## ARCHITECTURAL REVIEW BOARD STAFF REPORT

| <b>Project #/Name</b>         | <b>ARB-2022-63: Towneplace Suites Final Site Plan</b>   |
| <b>Review Type</b>            | Final Site Development Plan   |

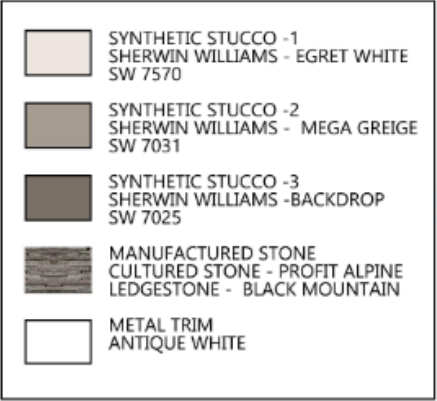
| REF | GUIDELINE   | RECOMMENDATION<br>2/7/22  | ISSUE 8/1/22   | RECOMMENDATION<br>8/1/22 |
|-----|---|---|--|--------------------------|
| 2   | Visitors to the significant historical sites in the Charlottesville and Albemarle area experience these sites as ensembles of buildings, land, and vegetation. In order to accomplish the integration of buildings, land, and vegetation characteristic of these sites, the Guidelines require attention to four primary factors: compatibility with significant historic sites in the area; the character of the Entrance Corridor; site   | Confirm that the wall area under the butterfly roofs will not be lit.   | <br><i>Architectural design reviewed on 2/7/22</i>  |                          |

*Revised design for 8/1/22 review*

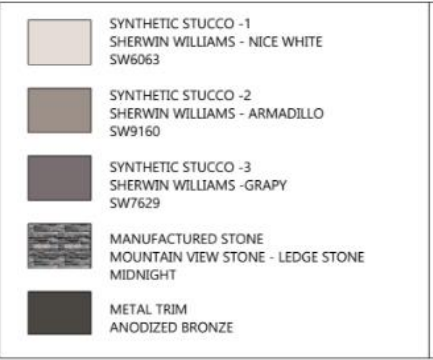
| 15 | Trademark buildings and related features should be modified to meet the requirements of the Guidelines.  | None. | The proposal is a version of a trademark design and the butterfly roofs are a feature of the brand. The staff report for the preliminary design included a recommendation to revise the angled roofs to a more traditional treatment, but it was not supported by the ARB. | None. |

The revised drawings show that the eastern and western wings of the building do not have angled roofs.

The lighting plan shows no lights under the angled roofs.
